H. B. ROBINSON UNIT 2 - DOCKET NO. 50-261
FACILITY OPERATING LICENSE DPR-23
ADDITIONAL INFORMATION FOR OPERATION AT 2300 MWt CORE POWER

H. B. ROBINSON UNIT 2

INSTRUCTION SHEET

AVERAGE POWER DENSITY (BOL), NO CONTROL RODS
FIGURE 3.2.1-5

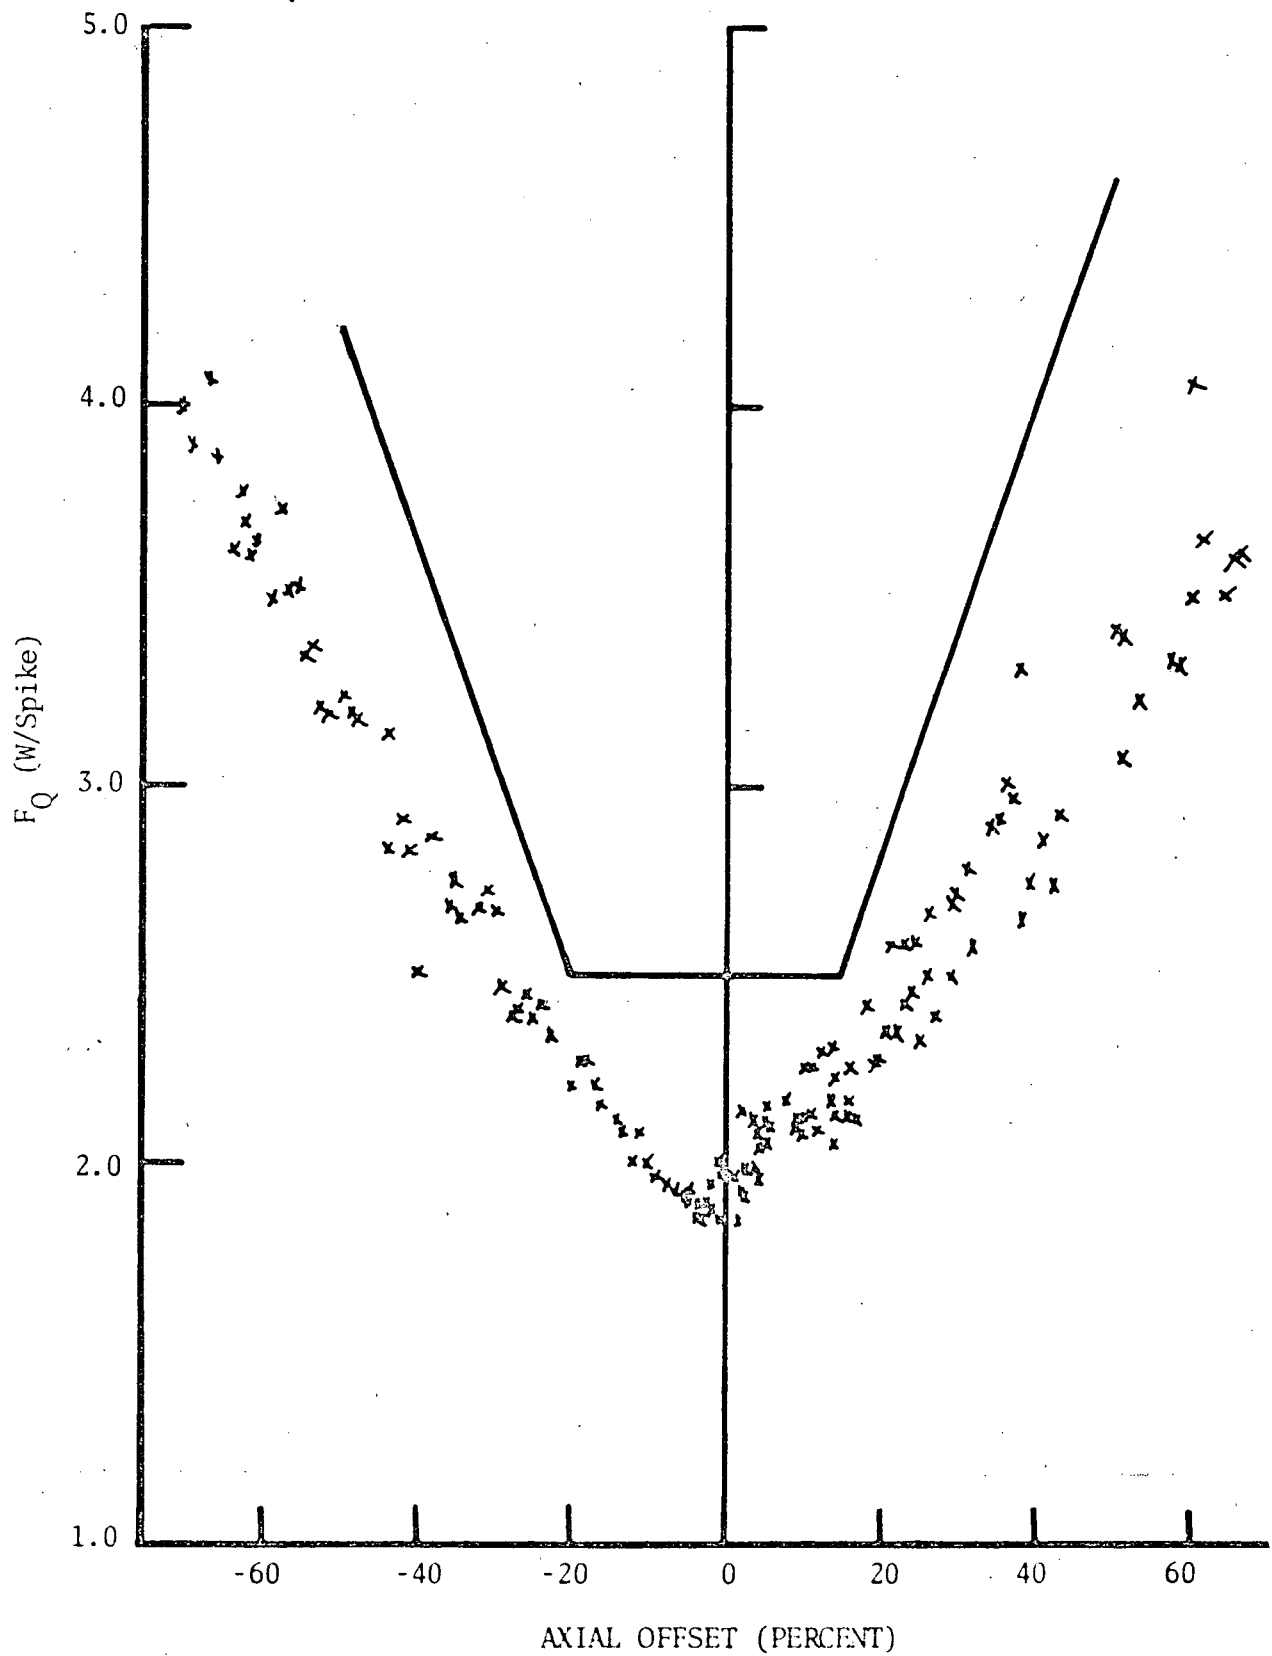
For Cycle 3 of the H. B. Robinson 2, the limiting F_q^T , including the effects of the local power peaking of Figure 3.2.1-36, are given in Figure 3.2.1-6. The results presented also include a 5% factor for uncertainty and 3% for manufacturing tolerances. At reduced power, high local rod power could occur as a result of a large axial offset and its resultant high F_q^T . For this reason, the plot contains points at large axial offset evaluated for less than full power, with an F_{xy} appropriate to rodded planes as determined by the control rod insertion limits in the Technical Specifications. The values of F_{xy} for the plane of the peak power were assumed to be no lower than 1.435 in the unrodded and rodded planes independent of burnup. The data supports an F_q^T boundary as low as 2.50 as shown in Figure 3.2.1-6, which provides additional margin to the limiting F_q^T of 2.65 determined from the LOCA analysis in Section 14.3.2.

Figure 3.10-1

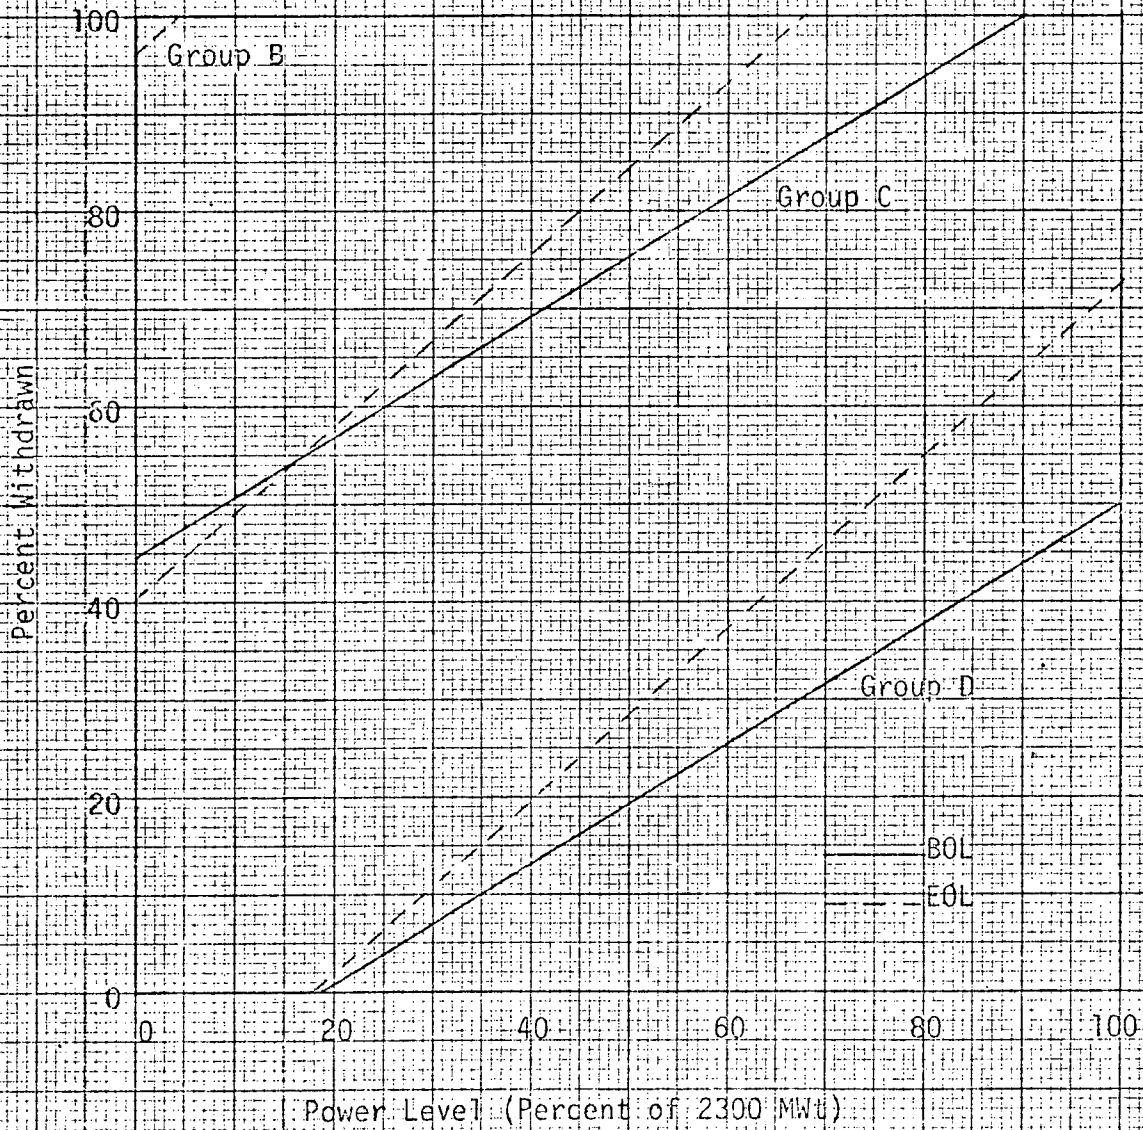
Transmitted herewith are three signed originals and forty (40) copies of additional FSAR and Technical Specification page changes in support of our application for amendment of the H. B. Robinson Unit 2 license to allow operation at a core power level of 2300 MWt. The FSAR page changes incorporate information contained in WCAP-8243, "H. B. Robinson Unit 2, Justification for Operation at 2300 MWt," December, 1973, concerning overpower protection system limits based on excore surveillance including the effects of fuel densification. The page change to the Technical Specifications updates the Control Group insertion limits for three loop or two loop operation based on final design calculations for Cycle 3 operation.
